Dominion Load Forecast Adjustment Questions

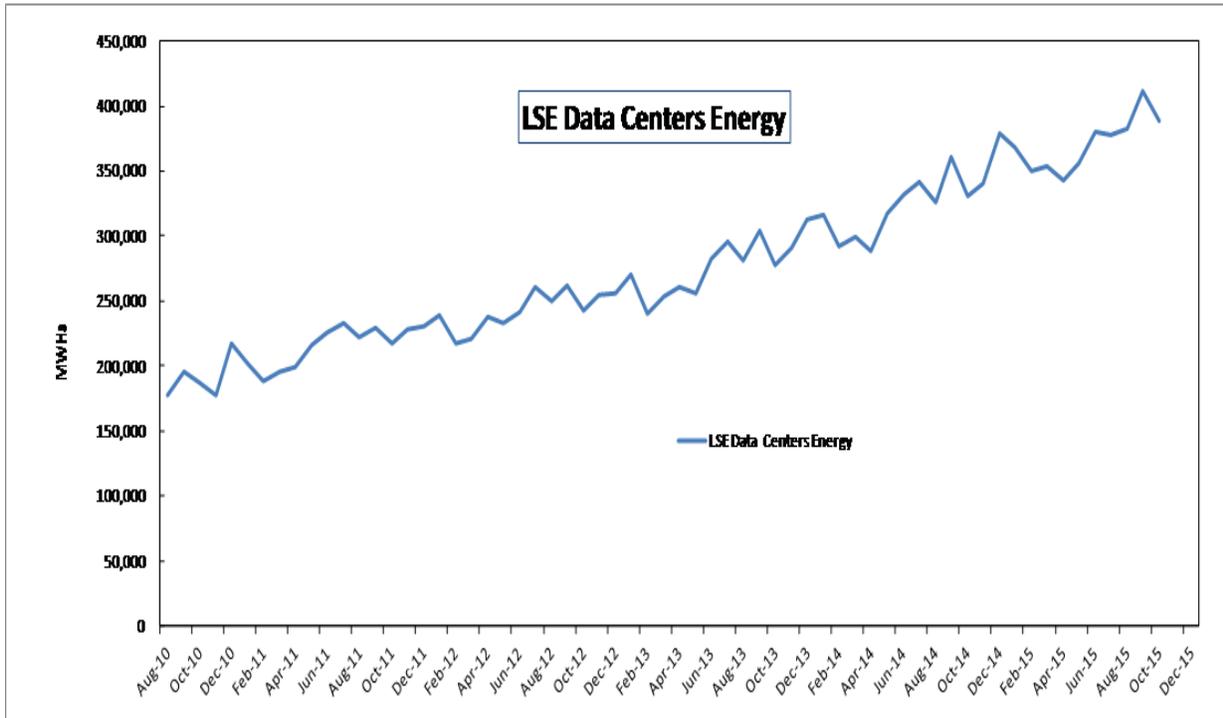
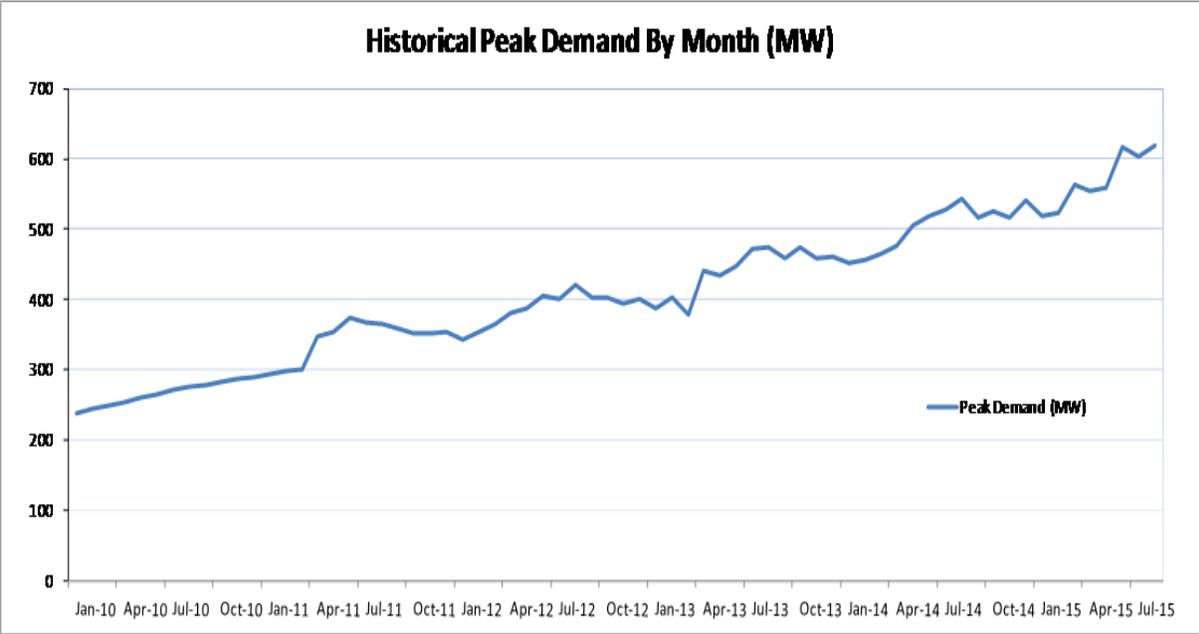
- a. What is the historical trend of total data center load, 1998 to 2015.

See the charts below, which show aggregate historical LSE data center load (in MWh) from August 2010 to November 2015 on a monthly basis, and the aggregate historical peak demand (MW) by month from January, 2010 to July, 2015. Note that this only reflects the LSE portion of data center load for the DOM Zone (does not include wholesale load).

The energy chart shown above (answer to 1.a) represents the average monthly load (in MWh) for all data centers. The peak demand chart represents the peak monthly demand (MW) for all data centers.

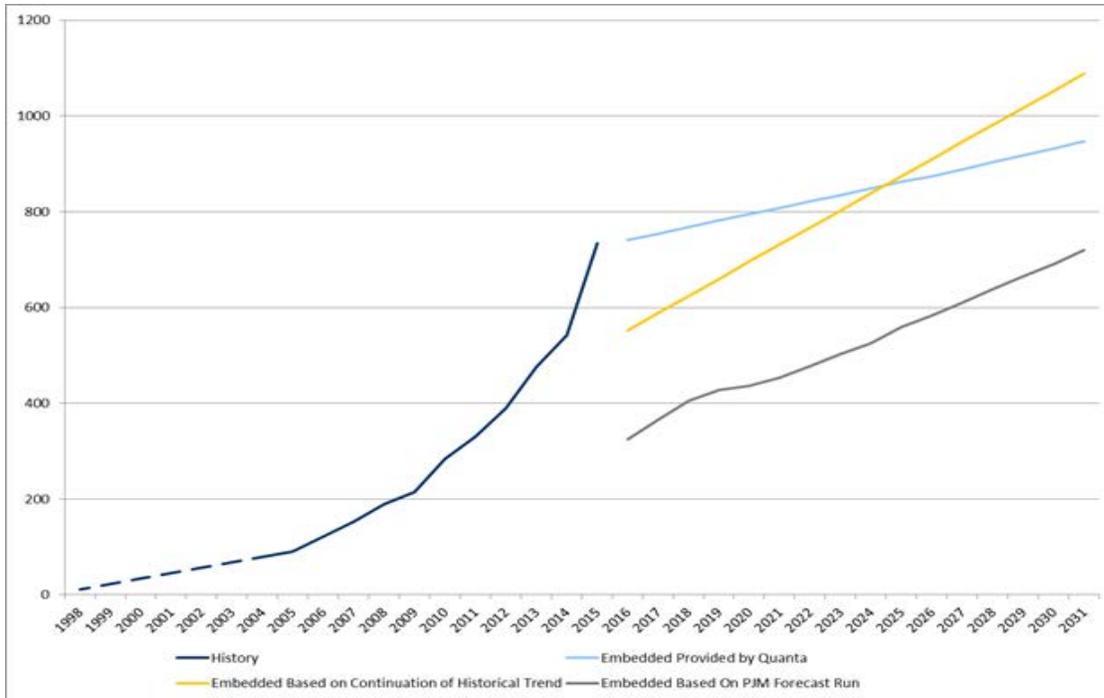
e. What is the total data center load that has been the basis for RPM payments?

In summer 2015, the coincident load of the data centers at the time of the PJM peak was approximately 610 MW.

The PLC calculation used for RPM payments takes the average load of PJM's five concurrent peaks (5 CP) from the previous summer. Load is grossed up for both distribution and transmission losses and scaled so that the average DOM zone load during the PJM 5CP match PJM's forecasted capacity obligation. This process is performed at the DOM LSE level.
